Re: Oxford Retention Basin Multi-Use Enhancement Project

We are pleased to submit the referenced project for final design approval. The following is a summary of our response to comments received during our last meeting with the Design Control Board (DCB) in September, 2012. The Project Design Concept is also enclosed to provide a thorough Project Scope of Work.

## OXFORD RETENTION BASIN

**A DECOMPOSED GRANITE w/ STABLIZER**

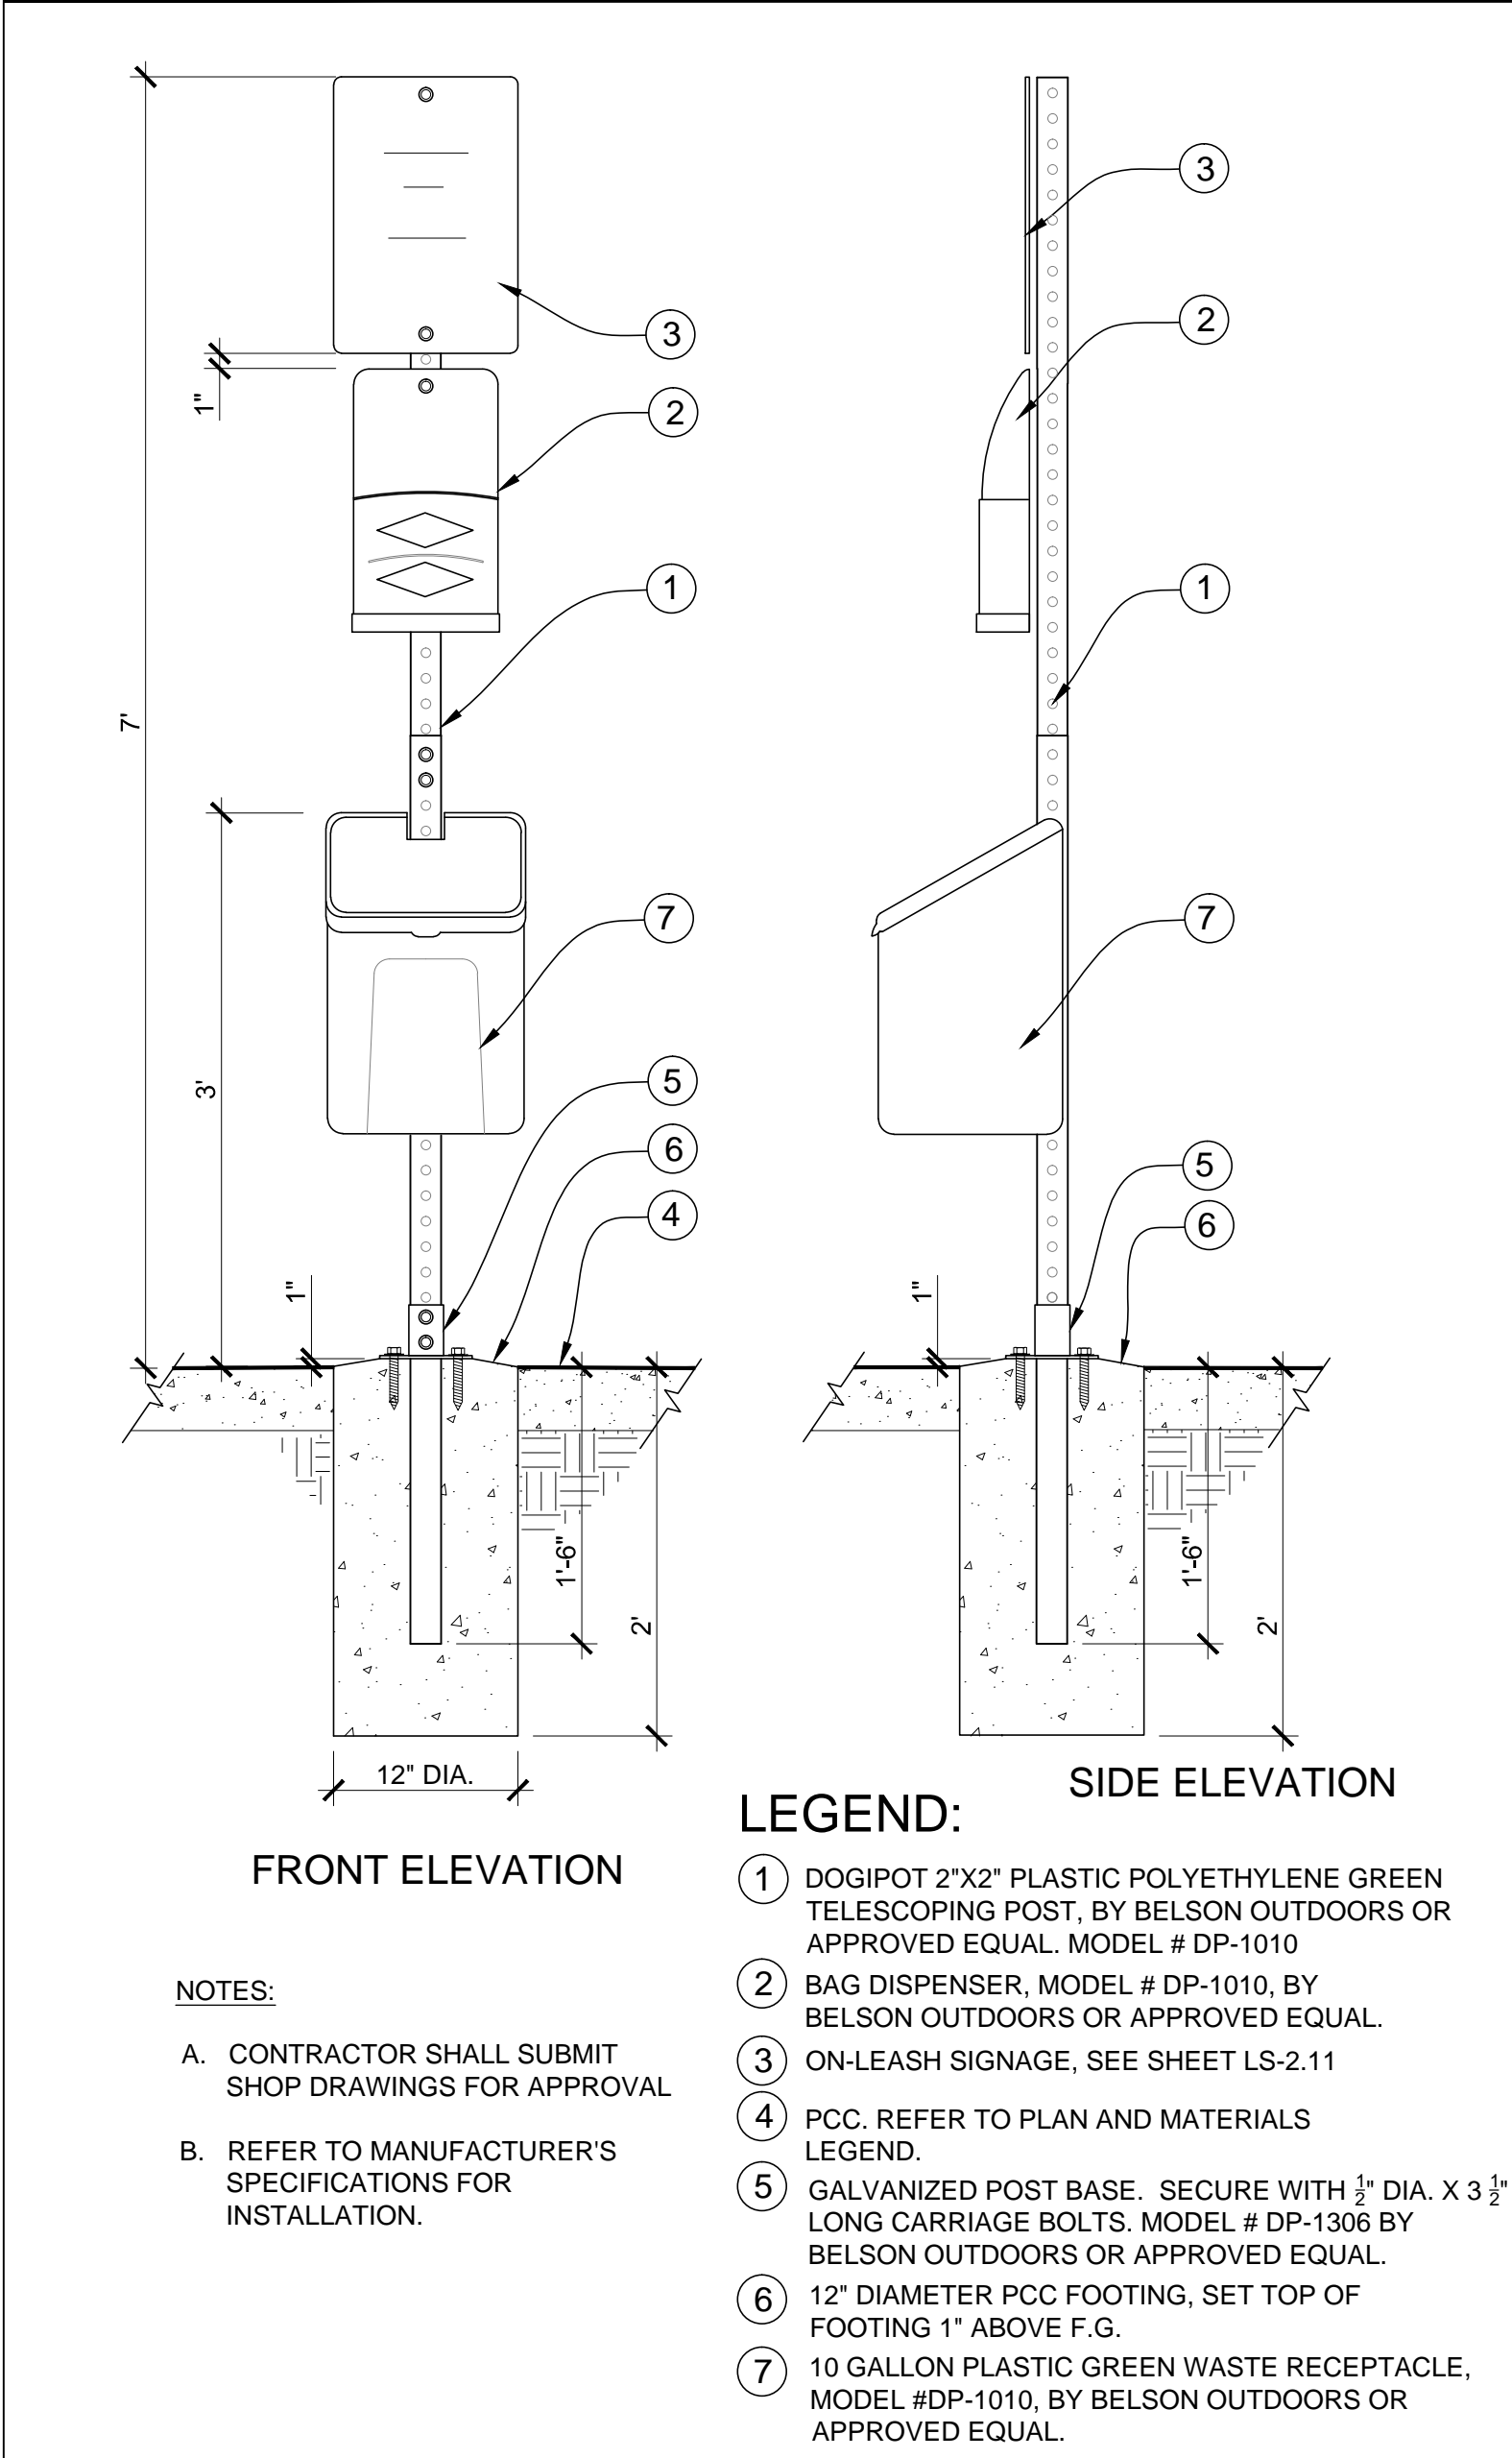
| #  | Comment   | Meeting               | Source        | Response   |
|----|---|-----------------------|---------------|--|
| 1  | What do you mean by “stabilized decomposed granite”? Will it be sprayed with oil? Will the stabilizer contaminate the water?  | DCB-September 19,2012 | DCB's Chair   | The DG will be mixed with the stabilizer, which will not have any negative impacts to water quality.   |
